Add PCD File No.  
SF1921 and SF204

Per DCM Vol.1 Section 11.3.3,  
recommendation for the foundation  
preparation and embankment construction  
shall be provided for all permanent  
detention facilities.

At your request, personnel of J&K Geologic Services, (J&K), installed a total of 6 piezometers in The Glen at Widefield East on December 1, 2017, as discussed in our letter dated January 1, 2018, (J&K Job # 171201). Reference the attached Piezometer Location Plan, (Fig. #1).

**PRELIMINARY  
SUBSURFACE SOIL INVESTIGATION  
THE GLEN AT WIDEFIELD, FILING #7  
WIDEFIELD, COLORADO**

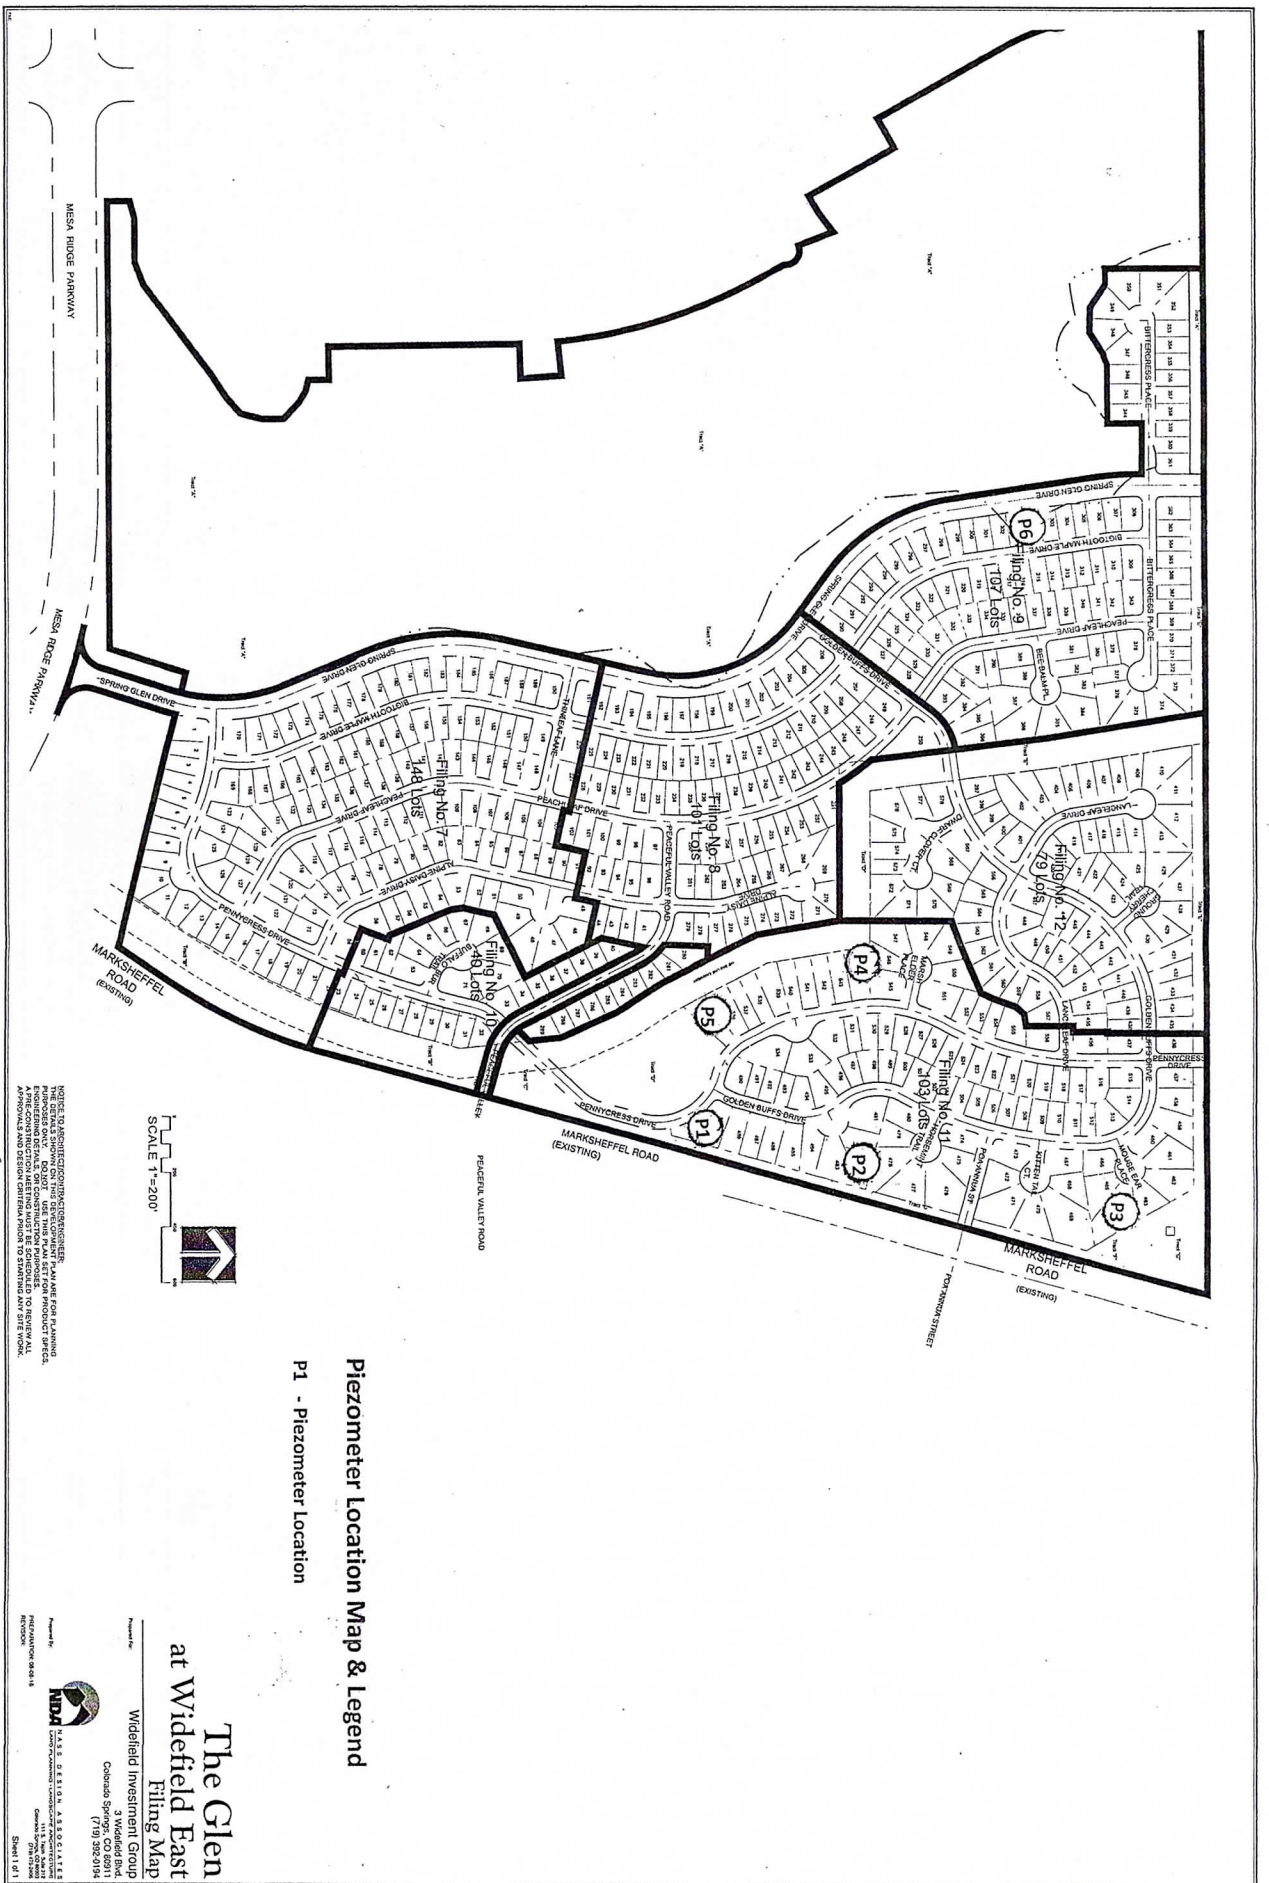
Any monitoring of  
Filing 10?
